Invitation to Bid: Construction Fire Station

49 Addendum 11

November 21, 2025

This is a cumulative response for architectural, structural, mechanical, electrical, plumbing and fire protection RFI's submitted to date.

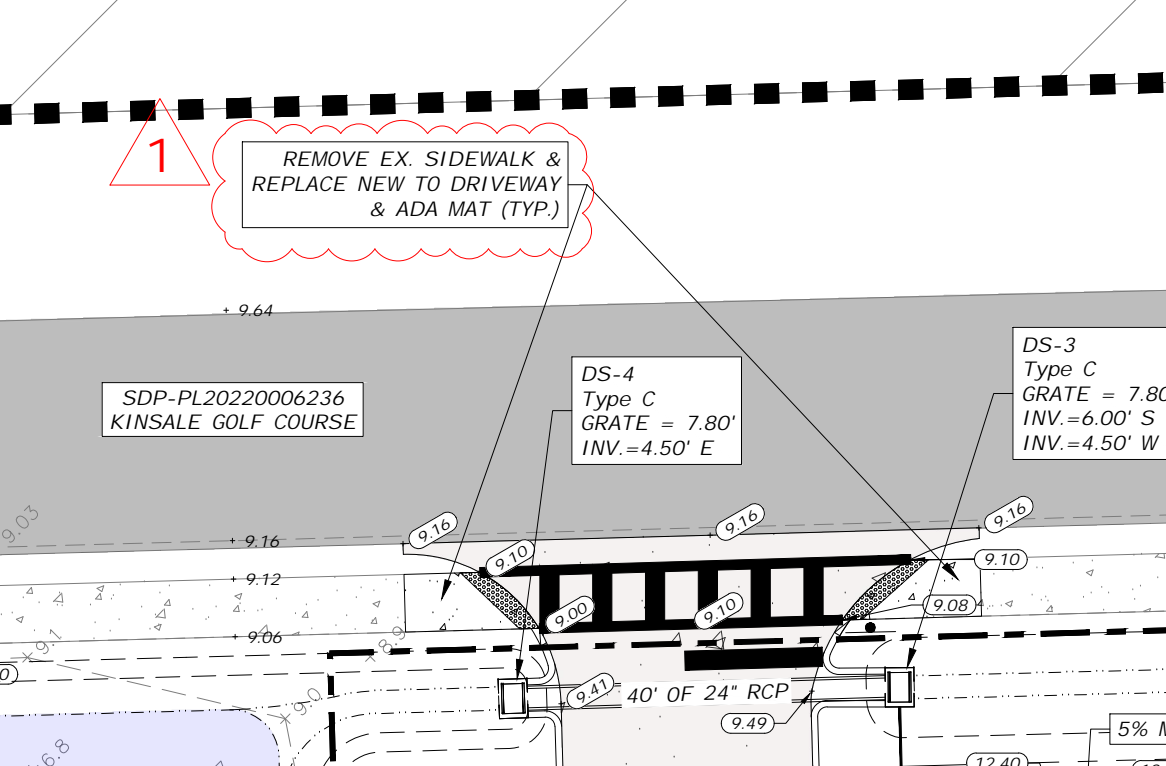
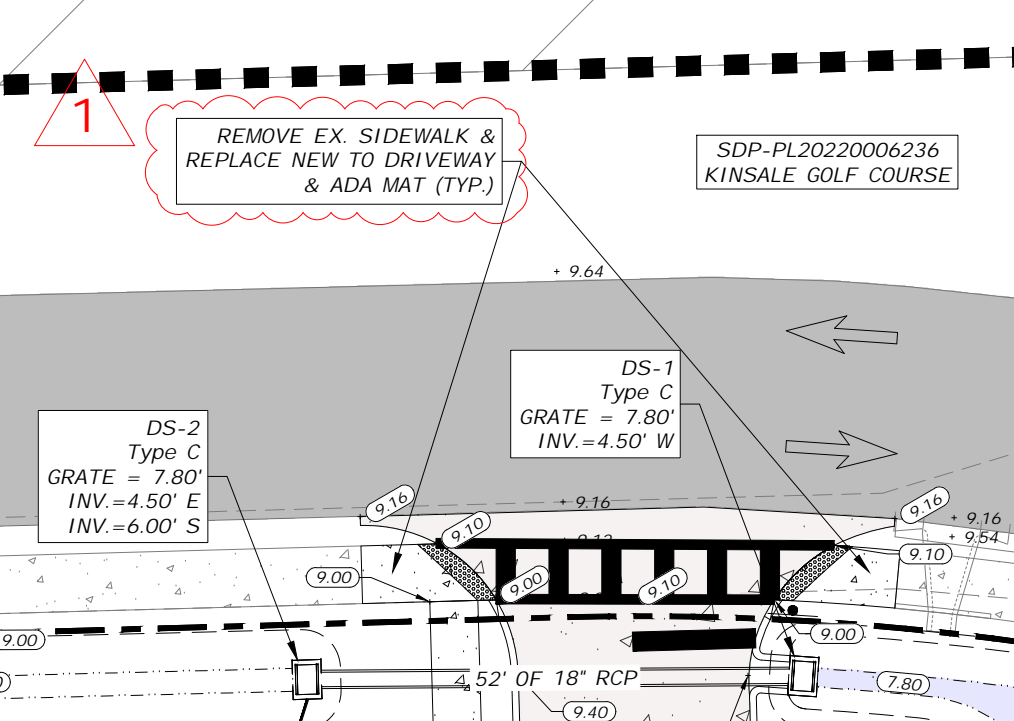
59. Please provide the extent of the existing sidewalk demolition.
- **Sidewalk demolition extents have been clarified. See attachment. The plan set shall be revised.**

REMOVE EX. SIDEWALK &
REPLACE NEW TO DRIVEWAY
& ADA MAT (TYP.)

REMOVE EX. SIDEWALK &
REPLACE NEW TO DRIVEWAY
& ADA MAT (TYP.)

FLUME DETAIL

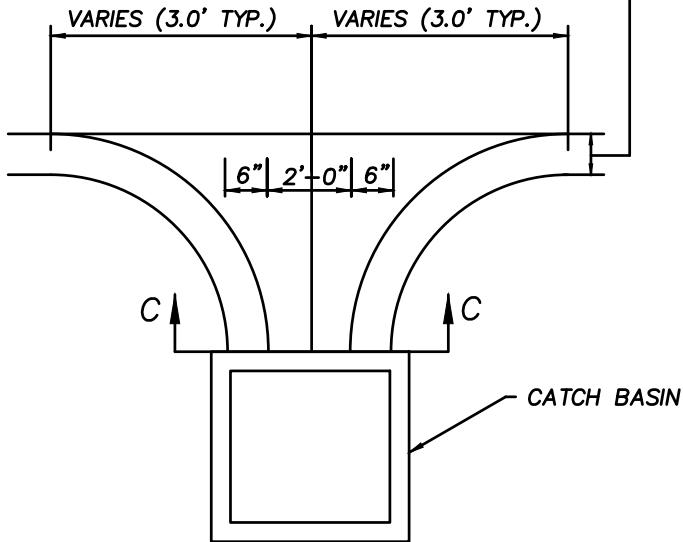
60. Please provide scale to civil sheet 06.
- **1"=20'-0"**
61. Please provide section/details for the drainage flumes.
- **See attached detail for flumes. The plan set shall be revised.**

PRODUCT SPECIFICATIONS

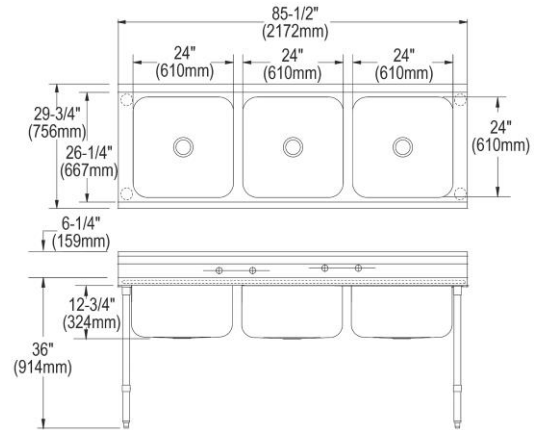
35. There is a 3-compartment sink labeled KS-1 on the plumbing plans that is not scheduled on the fixture schedule. Please provide specification information.

- **Elkay model #RNSF83724**
36. There is an eyewash in the apparatus bay shown in plan that is not scheduled on the fixture schedule. Please provide specification information.

WALL CLEANOUT KIT

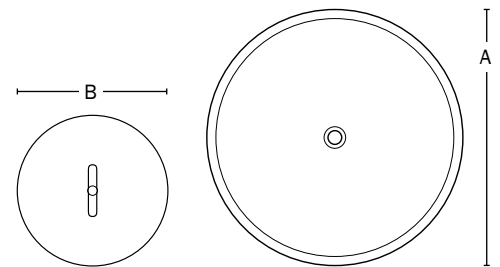
- **See Previous RFI Responses**
37. Please provide specifications information for the wall cleanout & two-way cleanouts on the plumbing drawings.

- **See attached.**
38. Plumbing notes call for new water piping to be in pex, copper or CPVC. Please clarify what type of piping is to be used for new domestic water piping on the project.

E1.5

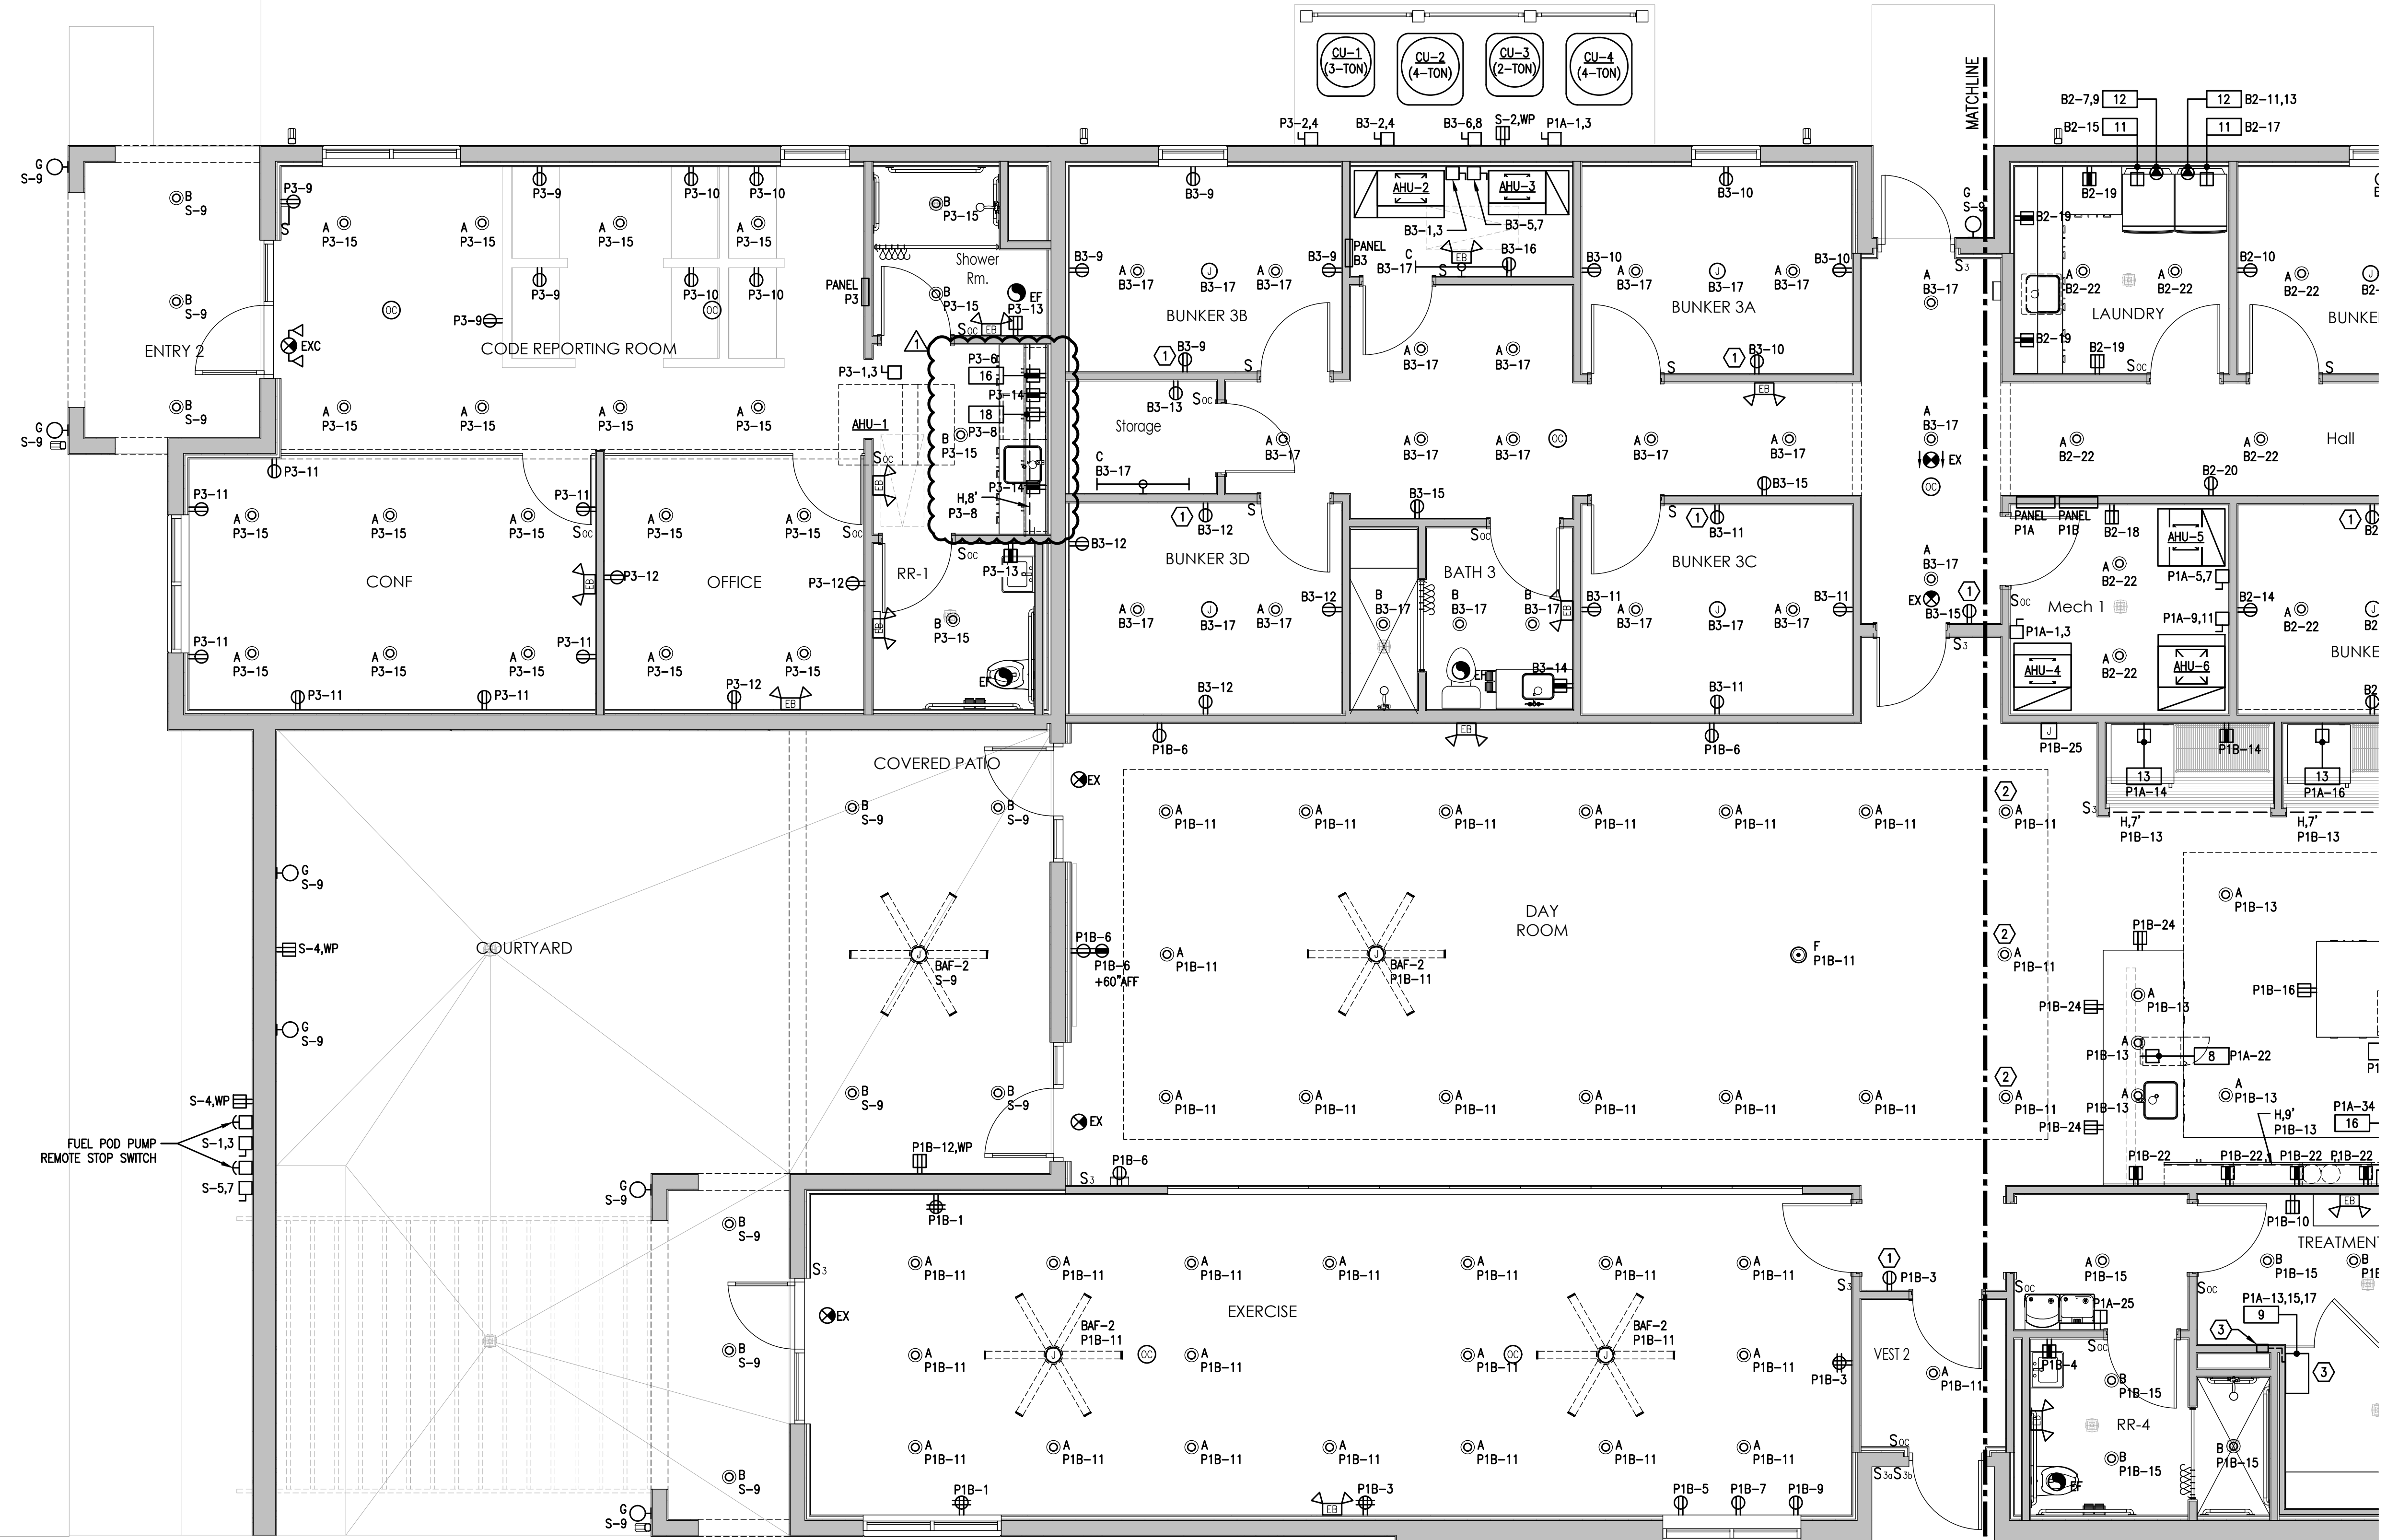
- **6-Gear Washer is shown on sheet E1.4 in the Gear Cleaning room.**
5. Please provide location for the 60A lift station as shown in Panel S. No location shown on Prints.

- **This is an acceptable alternative.**
 51. Will an electrical site plan be issued? Nothing is shown for power the lift station, Irrigation System, Etc.

- **See Electrical Site plan, sheet E1.5**
6. What is the purpose of the USB connection at the TV locations?
 - **See Previous RFI Responses**
7. Are they expecting to run a USB cable from each TV location to the IT closet Homerun?

- **Electrical site plan added in previous RFI. Lift station now located on electrical site plan. Irrigation electrical information has yet to be determined.**

E1.2

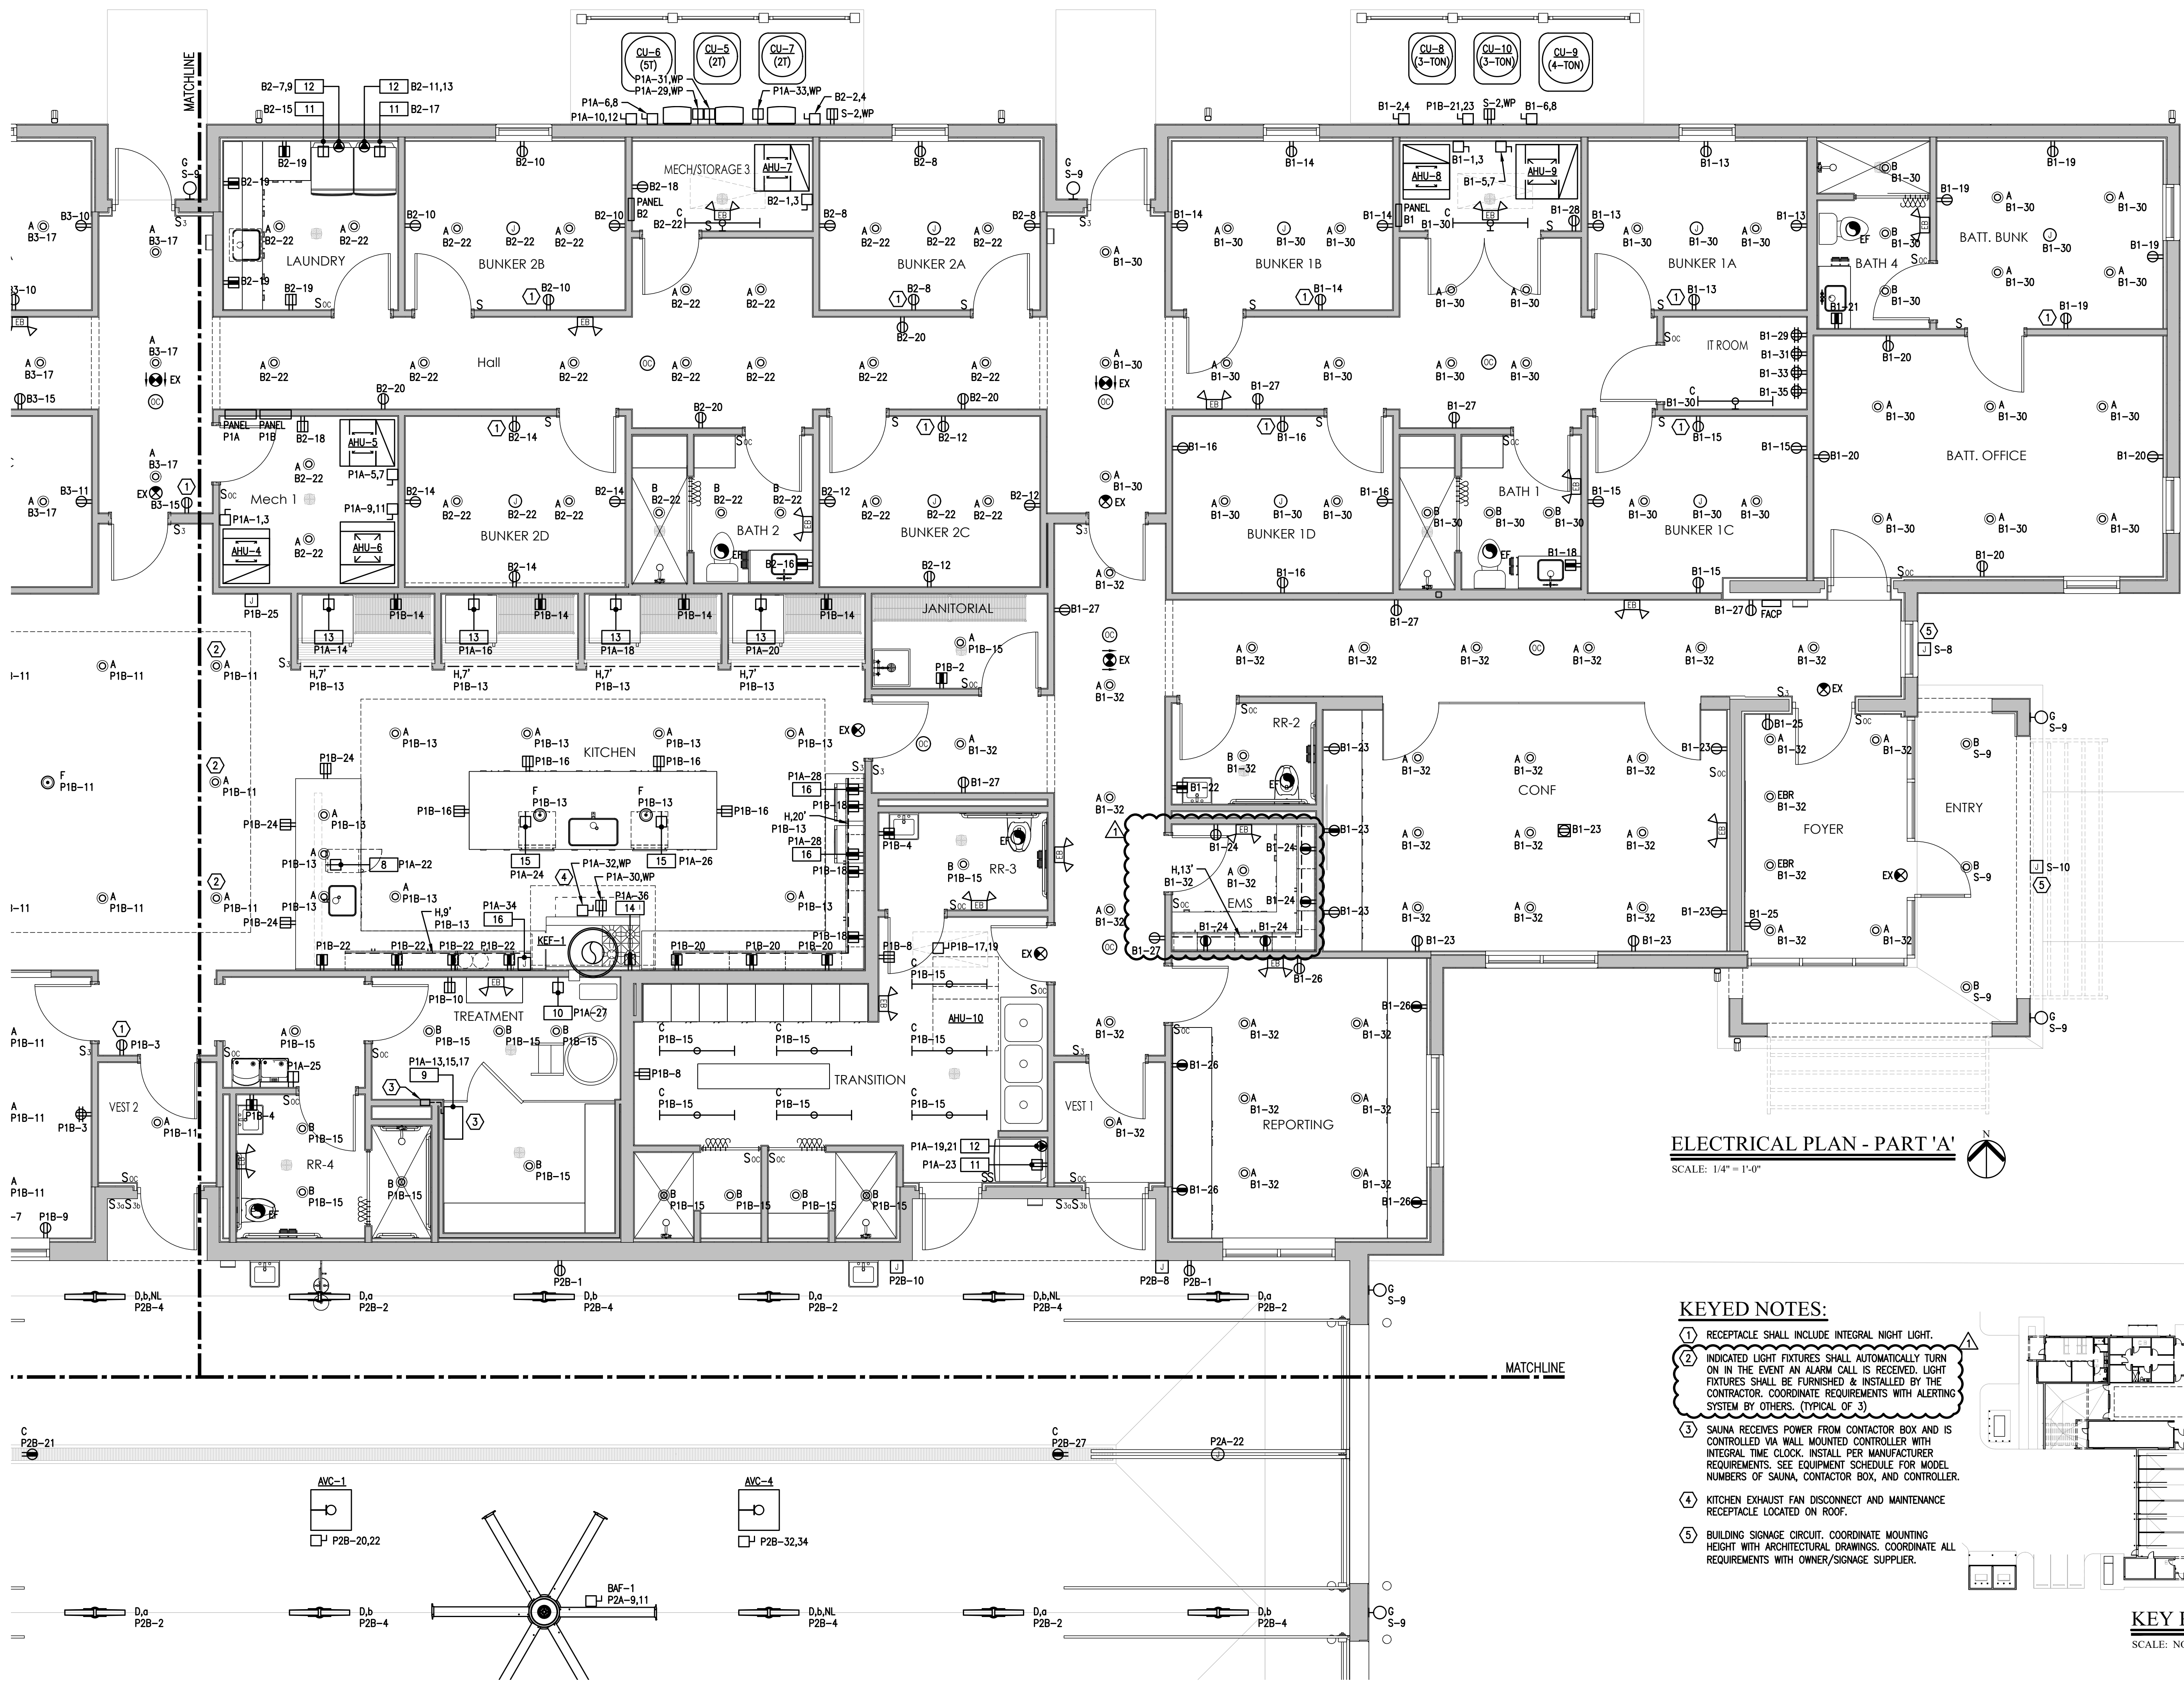
- **See Previous RFI Responses**
57. Please clarify the specifications for the under-cabinet lighting reference on sheet A6.2 detail 1 (Open office elevation #1).

- **The fixture H can be used in all under counter lighting such as in the kitchen, office break room, and EMS storage. See revised sheets E1.2 & E1.3. The plan set shall be revised.**
